AE2990 AFS
CB Handheld Radio for AM, FM and SSB

Service Manual

Servicemitteilung zu AE 2990 AFS v. 21.2.2011

Service Note 2990 AFS issued 21. 2. 2011

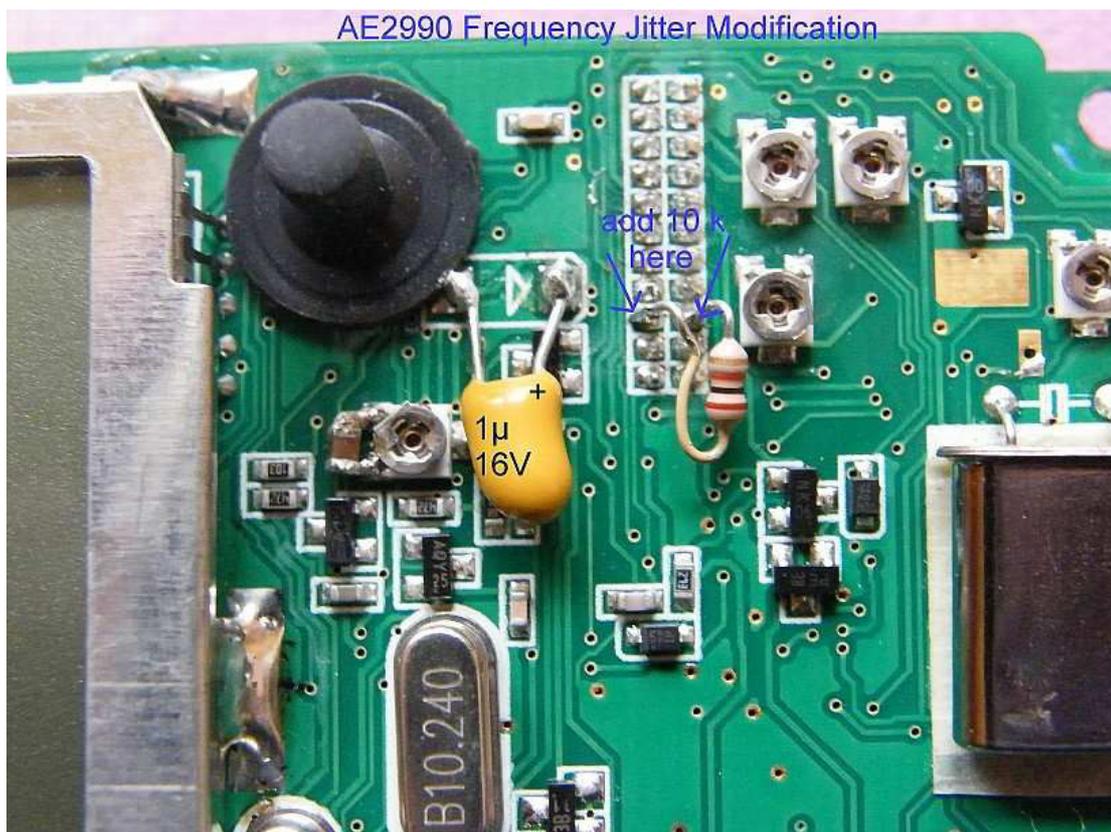
Bei einigen Geräten der ersten Produktionsserie Dezember 2011 wurde bemängelt, dass die Sendefrequenz in SSB bei starker Modulation einen kurzen Einschwingvorgang vollführt. Dieser äußert sich darin, dass z.B. beim Pfeifen in das Mikrofon der Pfeifton während der ersten 10..20 Millisekunden etwa 100..200 Hz neben der Frequenz liegt. Eine Gegenstation wird den Ton als nicht konstant bezeichnen, er ist zuerst neben der Frequenz und wird dann sauber. In Foren wird der Effekt von den Usern als „Eiern“ beschrieben, technisch trifft der Begriff Jitter den Sachverhalt besser.

Ursache: Der Lastwechsel der ansteigenden Sendeleistung bei SSB beim ersten Sprechen bewirkt eine unerwünschte HF Rückwirkung auf den VCO. Die Phasenregelschleife erkennt das als Frequenzablage und regelt nach. Das Regelverhalten reagiert dabei kurzzeitig wie ein Überschwingen.

Users reported that units from first production lot show more or less a “frequency jitter” effect during strong SSB modulation. The problem occurs as frequency shift of about 100-200 Hz especially if users produce whistle tones into the microphone during the first 10..20 milliseconds of the tone duration. Distant stations report that the tone is not constant and becomes ok later.

Cause: A negative feedback from rising output power with SSB modulation can cause a short time frequency shift reaction of the VCO. The PLL and phase comparator circuits then try to compensate the VCO Varicap voltage.

1. Änderung eines Standard SMD **Elkos** von **2.2µF** in einen Tantal-Elko 1 µF (gelb) in der Phasenregelschleife nach obenstehendem Foto.

2. Zusätzlich kann man auch noch einen **zusätzlichen Widerstand** von ca. **10 kOhm** über die im Bild gezeigten Kontakte des Pfostensteckers (3. Kontaktebene von unten gerechnet, entspr. R 203) legen.

Dieser Widerstand wird aber nicht empfohlen, wenn jemand Wert auf gutes Einrasten auch im untersten und obersten der 400 Kanal-Bänder Wert legt (ggf. ausprobieren).

1. Change the original **SMD standard capacitor 2.2 μ F** into a **Tantalum capacitor of 1 μ F** capacity (yellow on above photo)

2. Additionally the effect can be further reduced by **adding an additional resistor 10 kOhm** parallel to the PCB plug contacts of the third row (seen from bottom). (Info: these contact points connect to R 203 on main board).

Because this additional resistor may cause longer lock-in periods on lowest and highest 400 CH band frequencies, we do not recommend this modifications to users who should use this configuration. In that case we recommend to check the lock behaviour with and without resistor.
